SERVICE BULLETIN

TITLE: FUSELAGE - WING FORWARD SPAR CARRY-THRU STRUCTURE INSPECTION AND/OR REINFORCEMENT

SYNOPSIS OF CHANGE

Figure 1

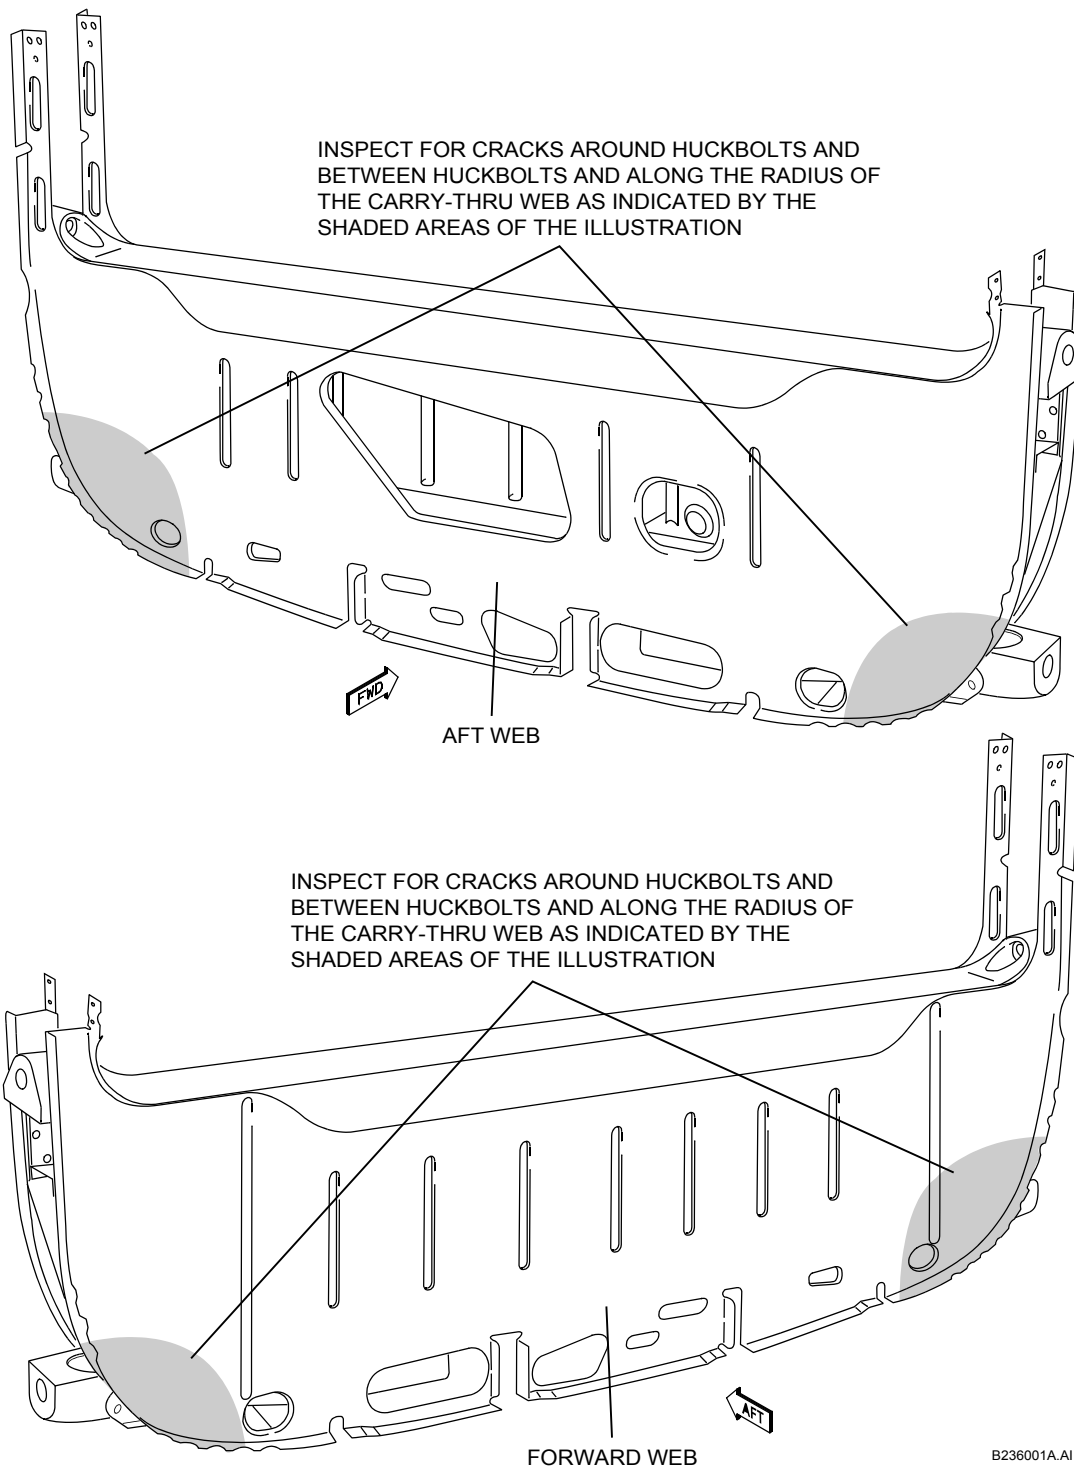
- (2) Remove the pilot's and copilot's seats and the carry-thru cover to obtain access to the front spar carry-thru structure.
- (3) Thoroughly clean the forward and aft frames (webs) of the front spar carry-thru structure in the shaded areas shown in Figure 1.
- (4) Perform a visual inspection of the area cleaned in step 3 for evidence of cracks.
- (5) Perform a dye-penetrant inspection, using visible dyes, of the area cleaned in step 3 for evidence of cracks.

Any of the shaded areas shown in Figure 1 that are modified by the installation of a doubler need not be dye-penetrant inspected until 1500 flight hours after the installation of that particular doubler. If no cracks are found, repeat the inspection every 500 flight hours.

Cracks found in the shaded areas of Figure 1 that have not been modified by a doubler must be repaired as indicated in this Service Bulletin on an individual basis.

The extent of repair is limited to cracking in the radius of the web flange and cracks in the web flat areas at the fasteners of the lower front spar cap.

- (a) For cracks in the bend radius:

- (i) A crack up to 4.0 inches in length shall be stop drilled at the ends using a #30 drill bit. The area is to be repaired per the applicable P/N 36-4004 Kit(s) within the next 100 flight hours, 12 calendar months or the next scheduled inspection whichever occurs first.
- (ii) A crack exceeding 4.0 inches in length shall be repaired PRIOR TO FURTHER FLIGHT per the applicable P/N 36-4004 Kit(s).

- (b) For cracks in the web face, in the area of the huckbolt fasteners:
- (i) A crack emanating from one fastener in two directions is considered to be one crack. **Do not stop drill, due to the possibility of damaging structure behind web face.**

- (ii) Any crack shall be repaired per the applicable P/N 36-4004 Kit(s), within the next 25 flight hours, 12 calendar months or the next scheduled inspection whichever occurs first.

- (iii) A crack passing through two fasteners and extending beyond for more than 0.5 inch on either end shall be repaired PRIOR TO FURTHER FLIGHT, per the applicable P/N 36-4004 Kit(s).

- (iv) A crack passing through two fasteners and extending beyond for less than 0.5 inch on both ends shall be repaired per the applicable P/N 36-4004 Kit(s), within the next 25 flight hours, 12 calendar months or the next scheduled inspection whichever occurs first.

- (c) If cracks are found in both the forward and aft frames on the same side of the airplane, in either the web face and/or the bend radius, and any of the cracks are more than 1.0 inch long, a repair shall be made PRIOR TO FURTHER FLIGHT.

- (d) If cracks are found in both the forward and aft frames on the same side of the airplane, in either the web face and/or the bend radius, and all of the cracks are less than 1.0 inch long, a repair shall be made per the applicable P/N 36-4004 Kit(s) within the next 25 flight hours, 12 calendar months or the next scheduled inspection whichever occurs first.
